**NEXTERA ENERGY POINT BEACH, LLC
POINT BEACH NUCLEAR PLANT, UNITS 1 AND 2**

**LICENSE AMENDMENT REQUEST 261
EXTENDED POWER UPRATE**

NON-PROPRIETARY RESPONSE TO REQUEST FOR ADDITIONAL INFORMATION

December, 2009

Figure 13a: Broken Loop and Intact Loop Pumped SI Flow

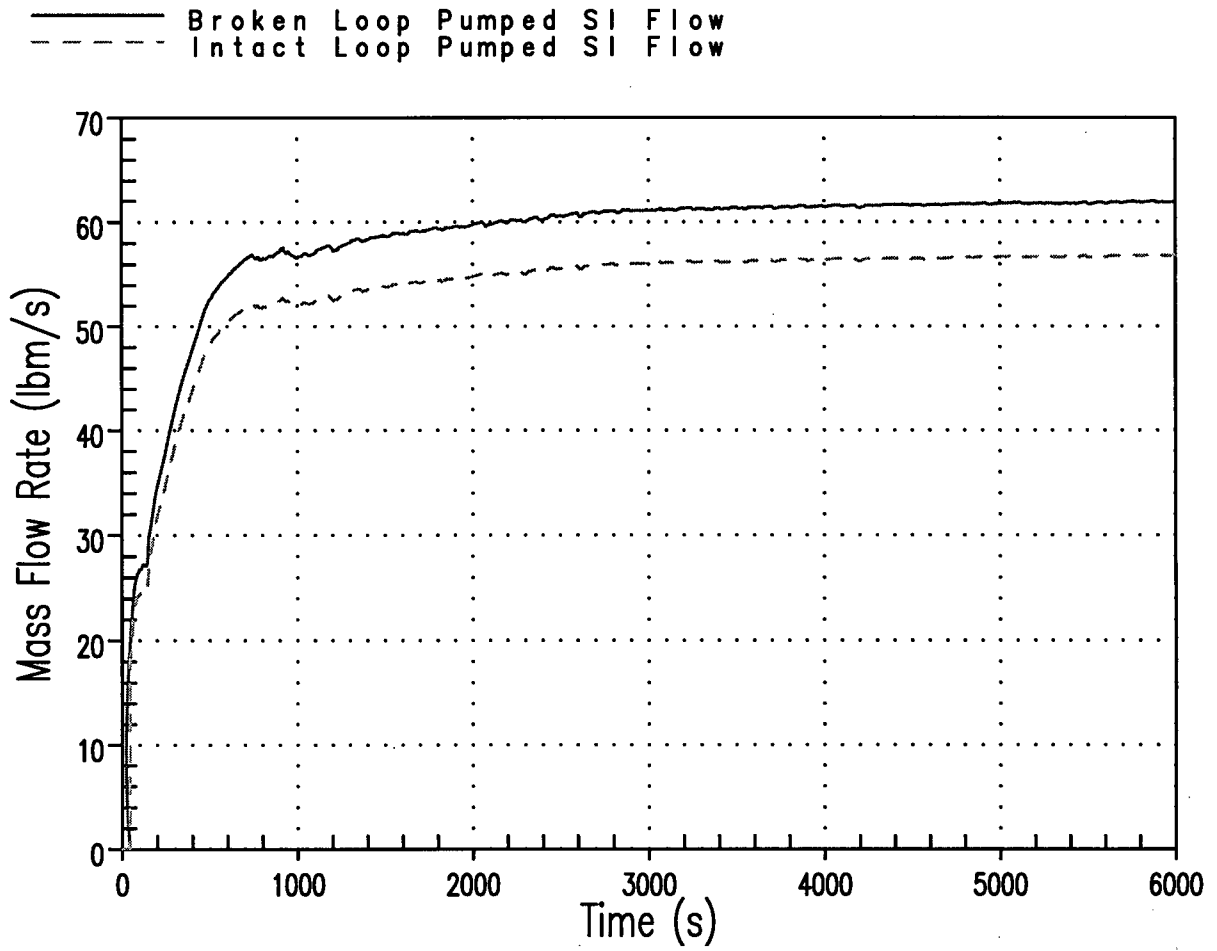
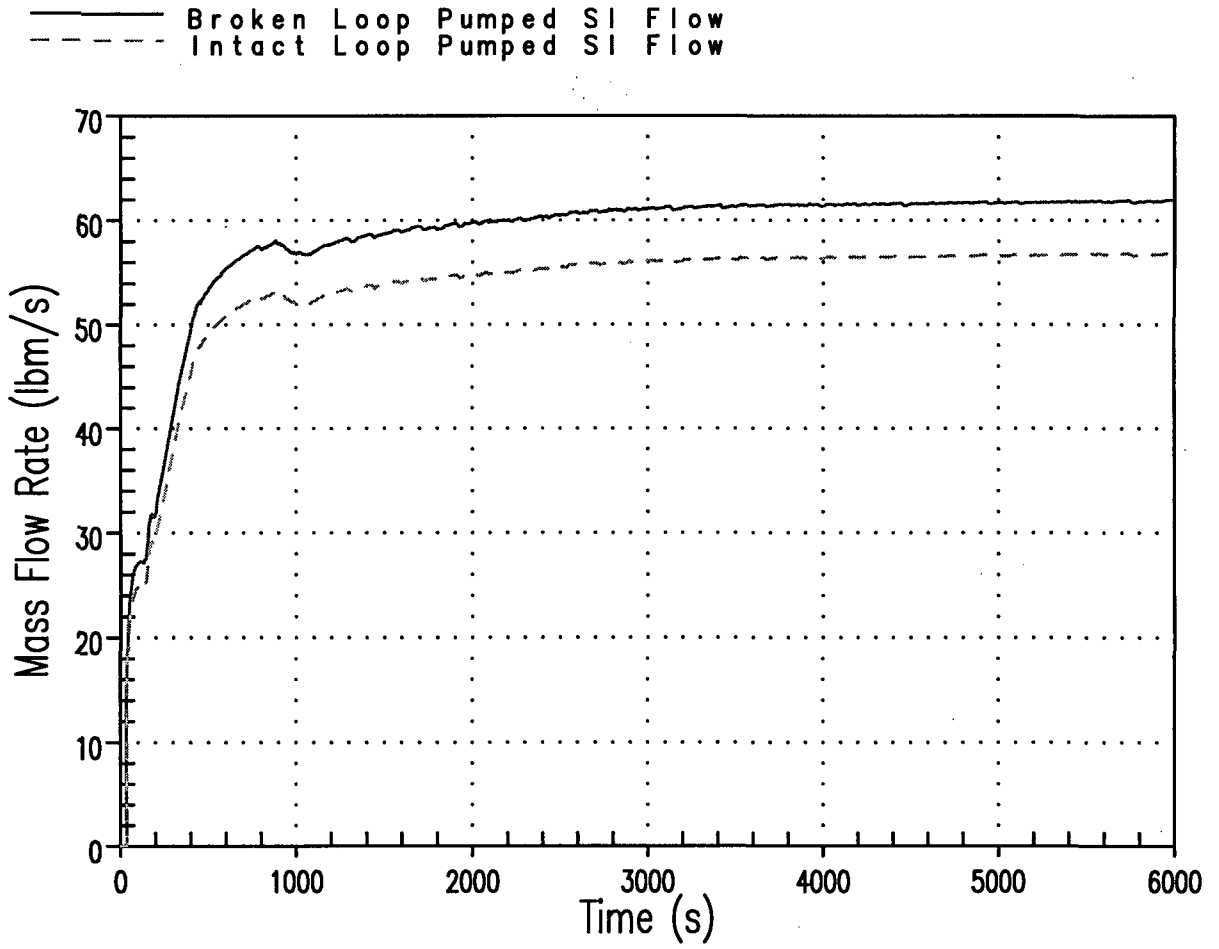
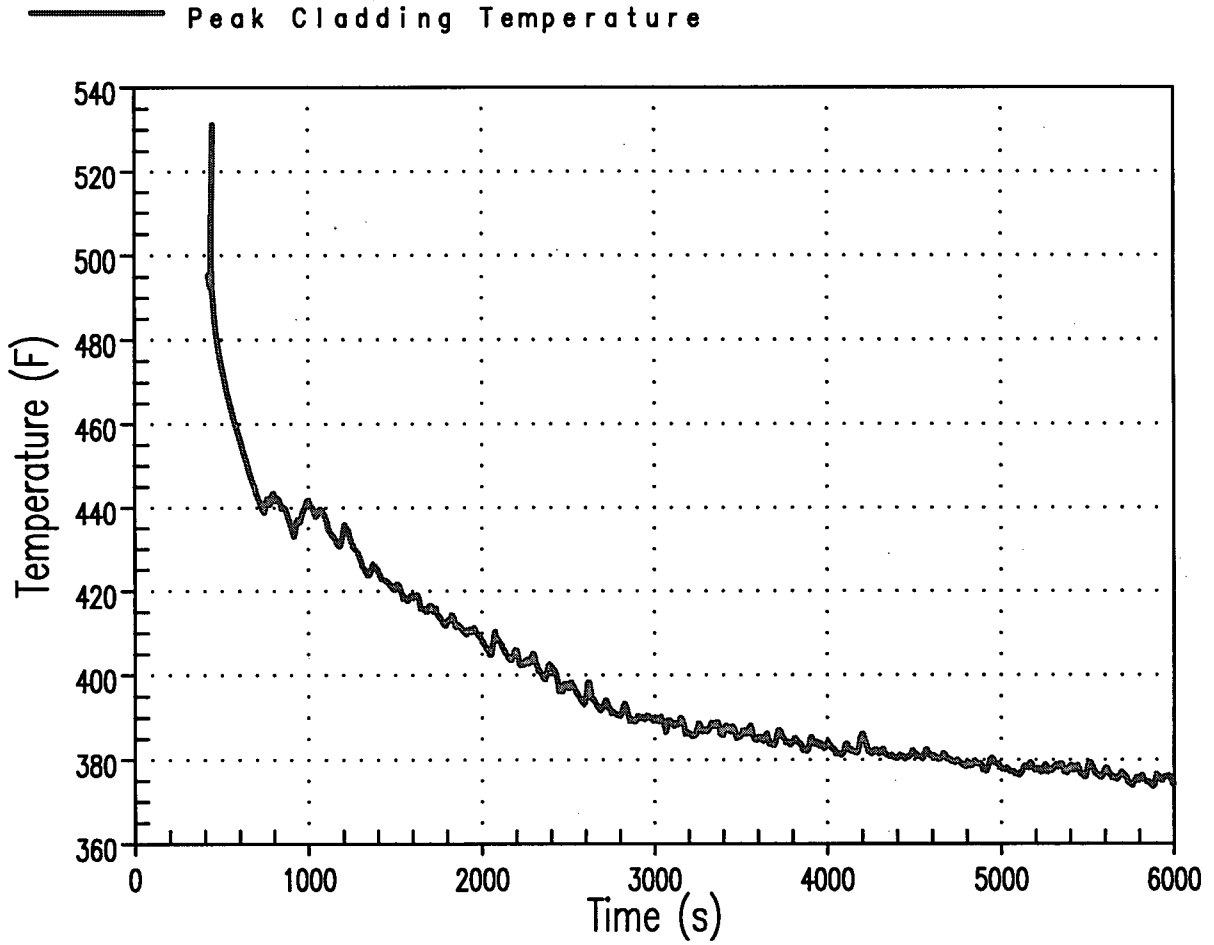
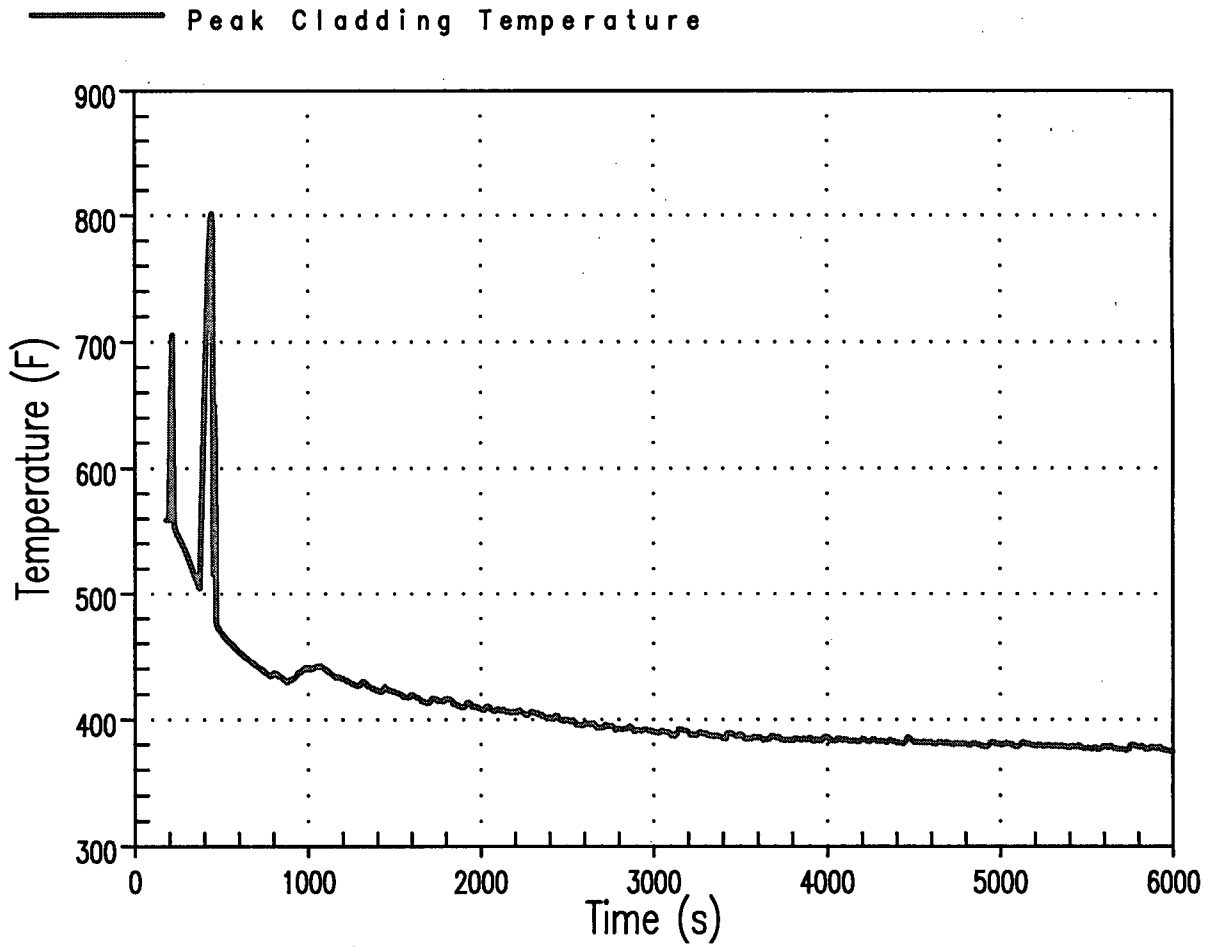
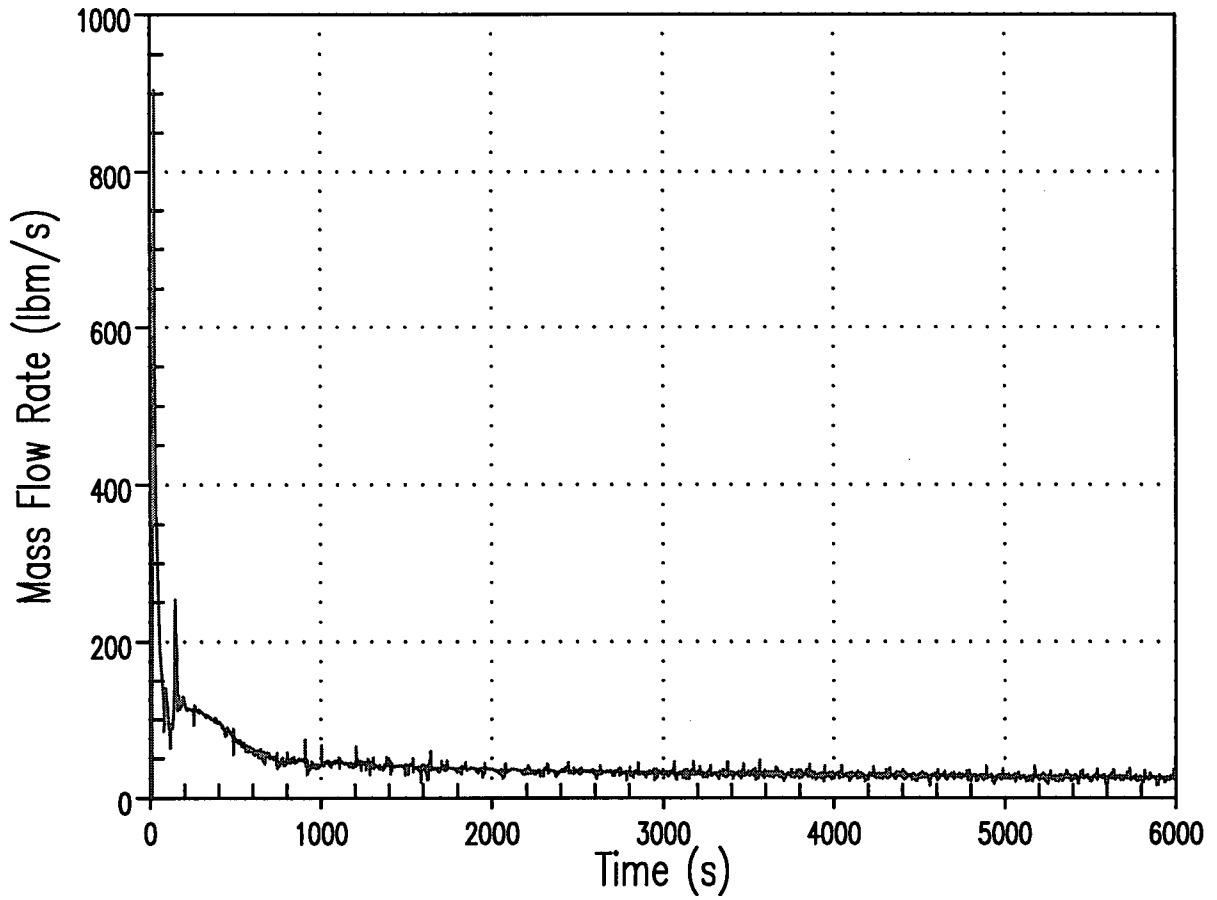
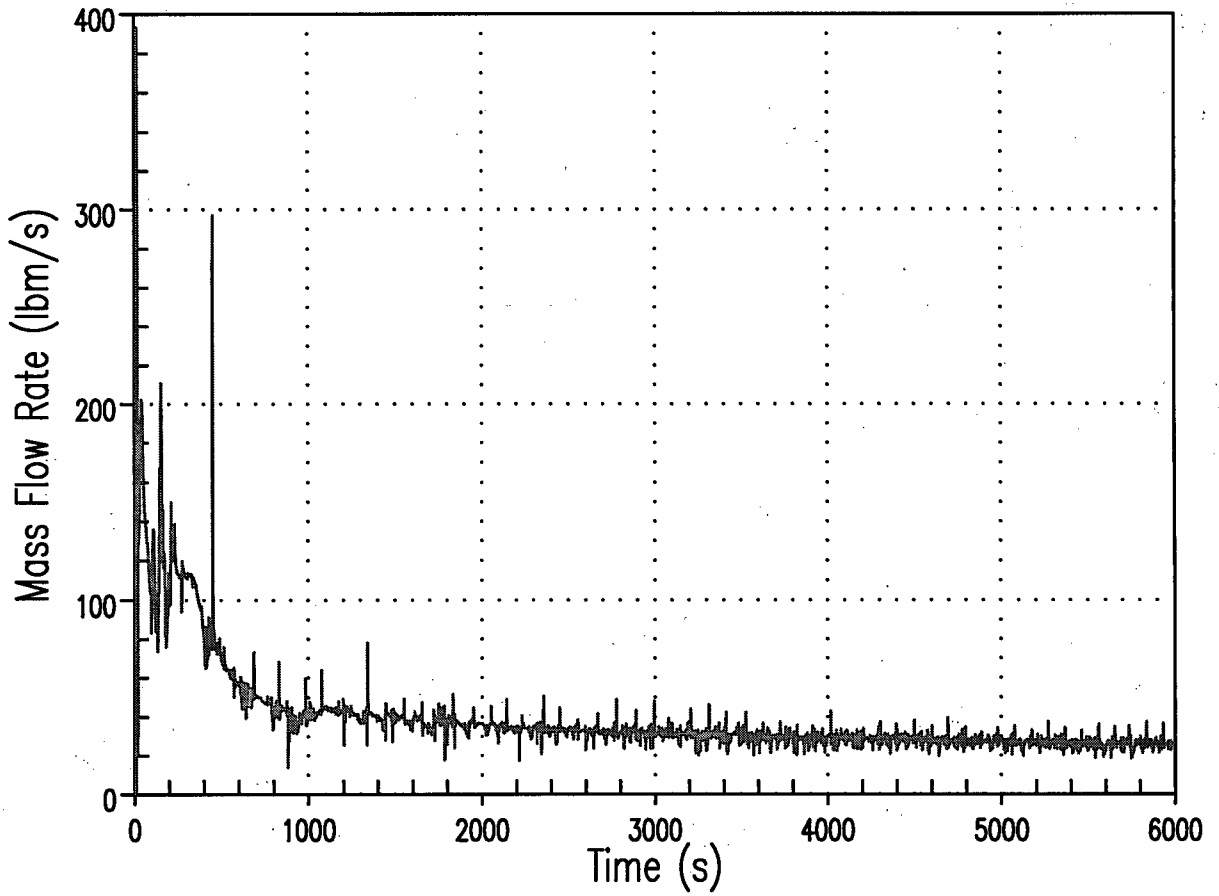
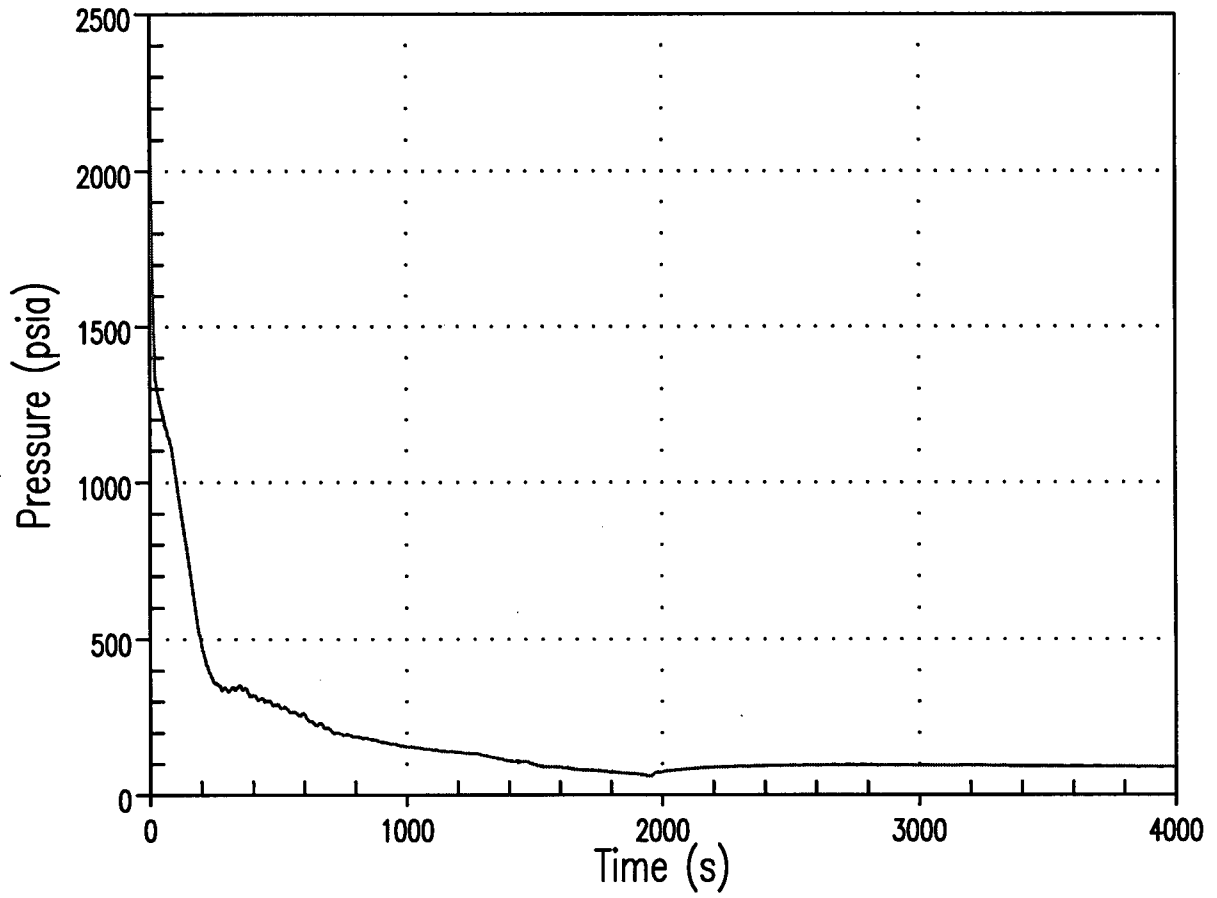
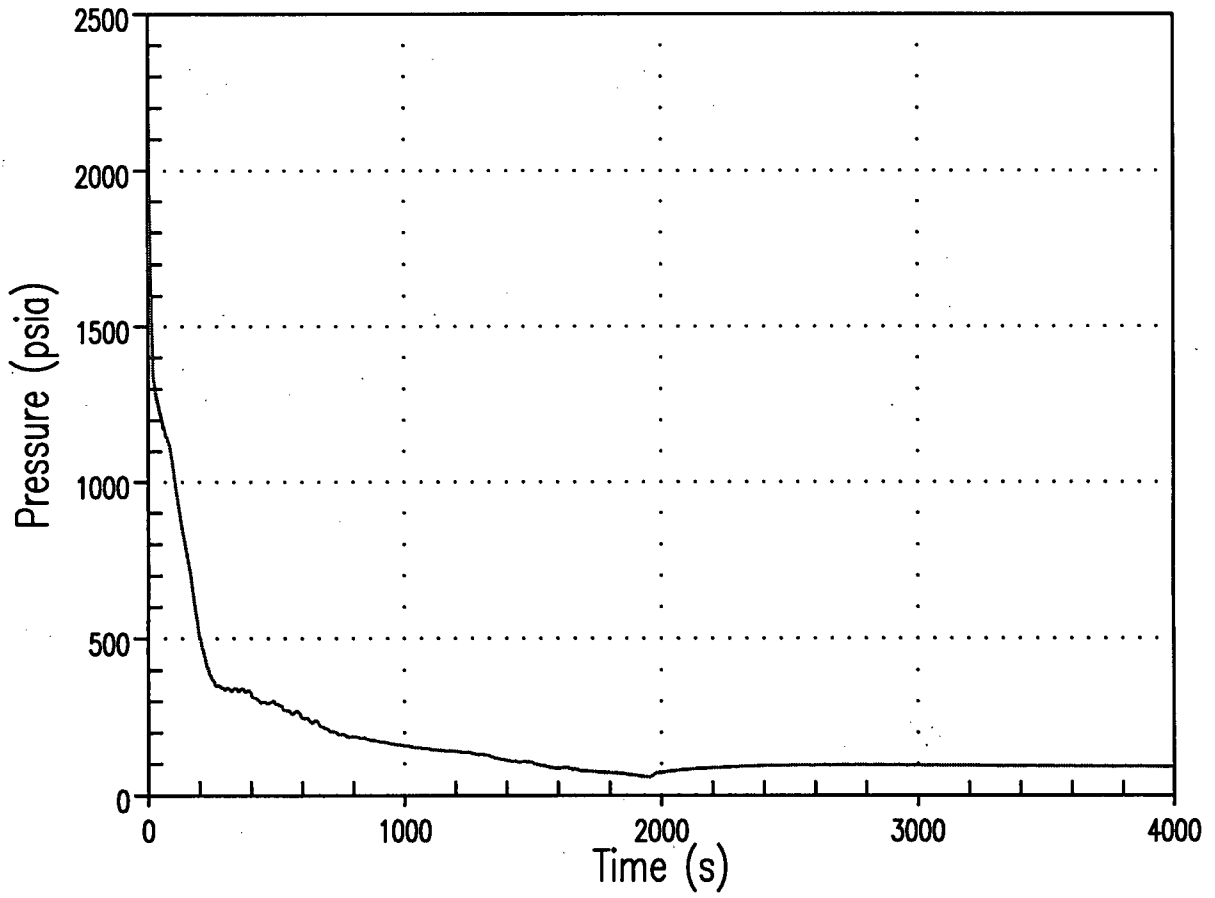
- 1) Page 2.8.5.6.3-6 of the Point Beach Extended Power Uprate (EPU) Licensing Report (Enclosure 5 to Reference 1) indicates that the small-break loss-of-coolant accident analysis was performed using the NOTRUMP evaluation model. Please provide a copy of the NOTRUMP analysis report that supports the EPU application.**

The NRC reviewer provided clarification of this RAI during a teleconference held between Westinghouse, FP&L, and the NRC. It was concluded that the transient response results of the non-limiting breaks, which are not provided in the LAR, will be provided. Transient response results for the limiting 3-inch break for both Point Beach Units 1 and 2 are provided in the small break LOCA LAR Section 2.8.5.6.3. The same response results for the non-limiting breaks are provided below. The following comments apply:

- Peak cladding temperature transients are not provided for the 6- and 8.75-inch breaks as these breaks experienced little to no core uncover.
- Low head safety injection flow figures are provided only for the 6- and 8.75-inch breaks. LHSI was only modeled for the 6- and 8.75-inch breaks (during RWST injection phase only). Breaks less than 6-inches in equivalent diameter did not reach the LHSI cut-in pressure.
